Submissions Report

Sydney Olympic Park Over and Adjacent Station Development

May 2024

Figure 3-2 Concept SSSA scope and Sydney Olympic Park metro station infrastructure, updated plan

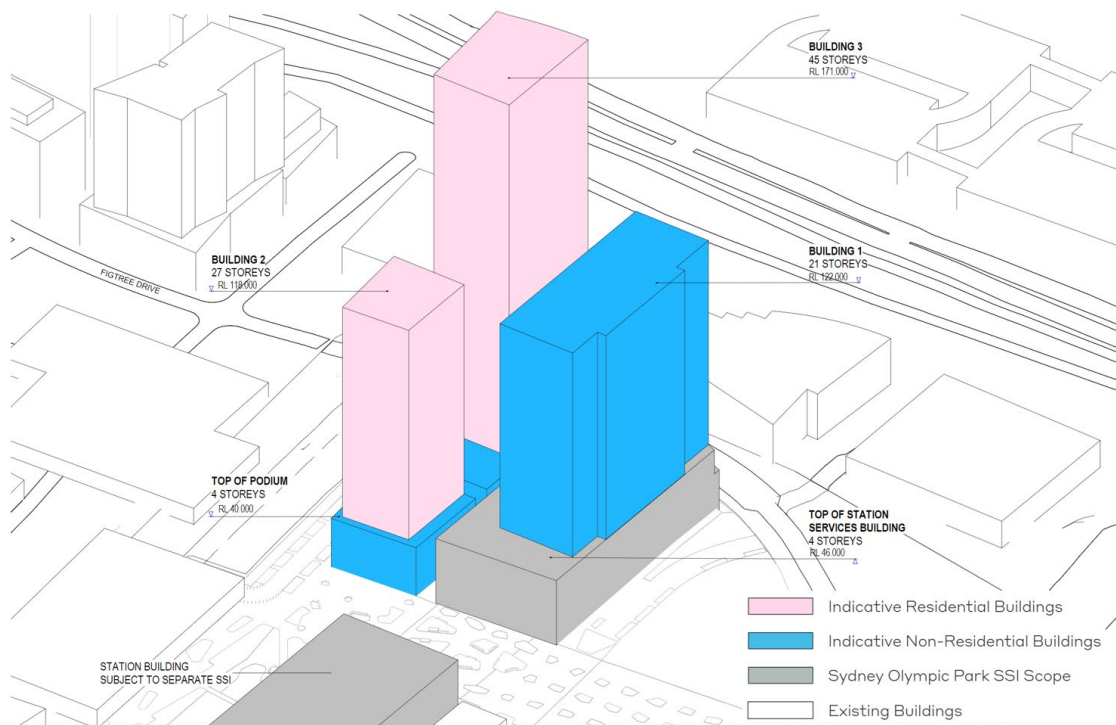
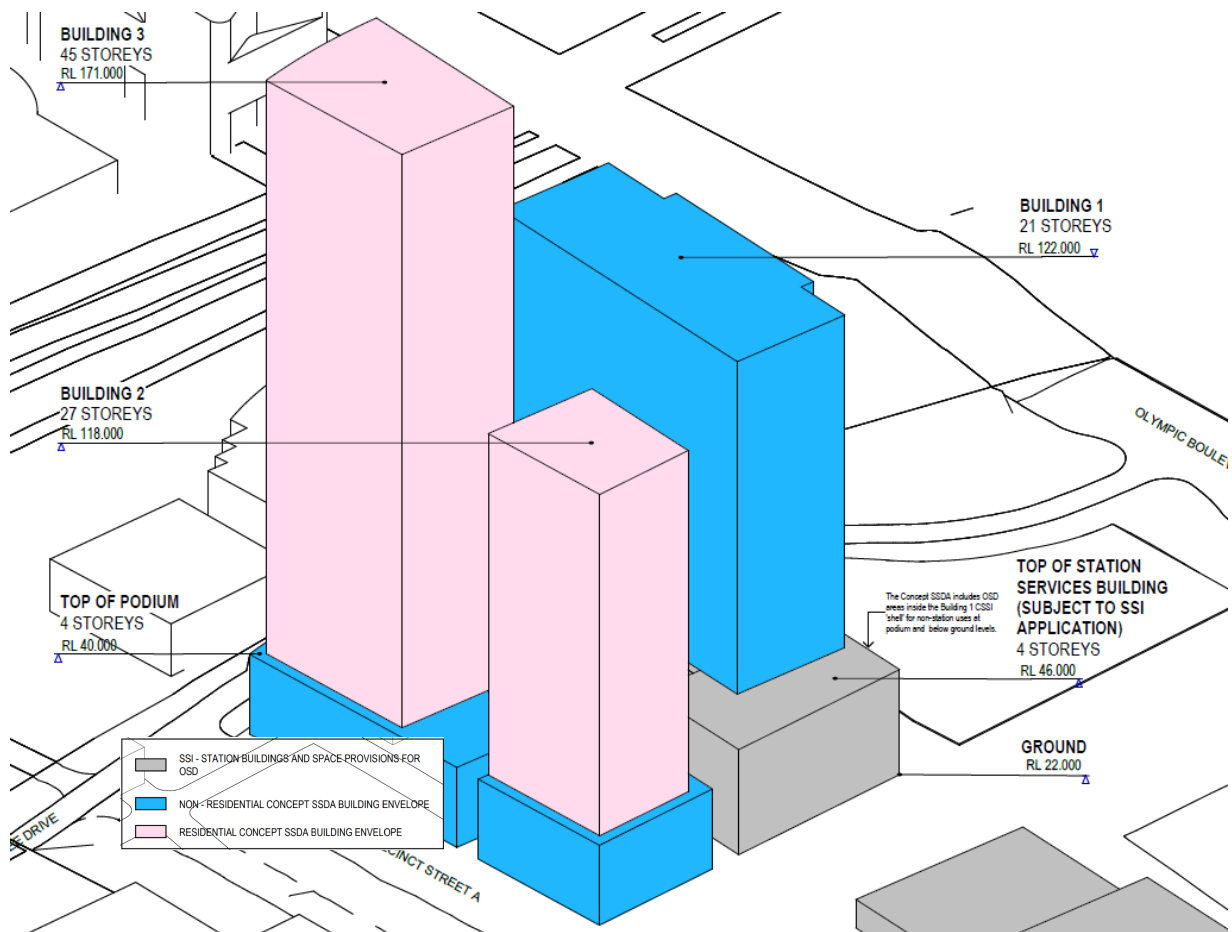
- Clarification of the Concept SSDA site boundary (to include a larger part of Precinct Street A and also to exclude public domain areas which form part of the Stage 3 CSSI Approval), in response to advice received from DPHI.

- Clarification of maximum building envelope heights as a result of an inconsistency noted between the lodged Building Envelope Plans and description of the proposal.

- Clarification of ground level RLs on the amended Building Envelope Plans, in response to advice from Sydney Olympic Park Authority.
- Clarification of the opportunity for increased activation of ground floor areas for non-station (OSD) uses within Building 1 which form part of the Concept SSDA. This is in response to advice from SMWDAP and Sydney Olympic Park Authority. The revised Ground Floor plan in the updated Indicative Reference Scheme at Appendix I shows a revised station entry point on the Promenade, plus an additional small retail unit facing the Promenade. The OSD entry lobby within Building 1 is shown re-positioned adjacent to Figtree Drive – and therefore is separate from the station entry points.

- Clarification of the podium northern setback of Building 2 relative to Building 1, in response to advice from Sydney Olympic Park Authority.
- Clarification of the minimum setback dimensions between envelopes for Building 1, 2 and 3 and separation from adjoining sites (to comply with Apartment Design Guide (ADG) part 2F for buildings of 9 storeys or more (i.e. 24m between habitable rooms / balconies; 18m between habitable and non-habitable rooms; 12m between non-habitable rooms), in response to advice from Sydney Olympic Park Authority.

The updated Concept SSDA building envelopes are shown in Figure 3-2 below – also included in the updated Building Envelope Plans at Appendix H.

The proposed refinement to the maximum GFA is minor, with the additional 960m² of GFA representing an increase of 1.4 percent of the total maximum GFA originally sought in the Concept SSSA. This has arisen from efficiencies in internal areas (such as reduction in the station plant level within Building 1 and relocation of the OSD entry lobby, enabling more commercial floor area within the podium, plus refinement of service core areas on each level in Buildings 2 and 3, enabling a minor increase in residential floor area). No change is sought to the exhibited building envelopes within the Concept SSSA, with the additional GFA to be contained within the maximum extent of these envelopes. These envelopes are within the 45 storey (RL 149) maximum height control.
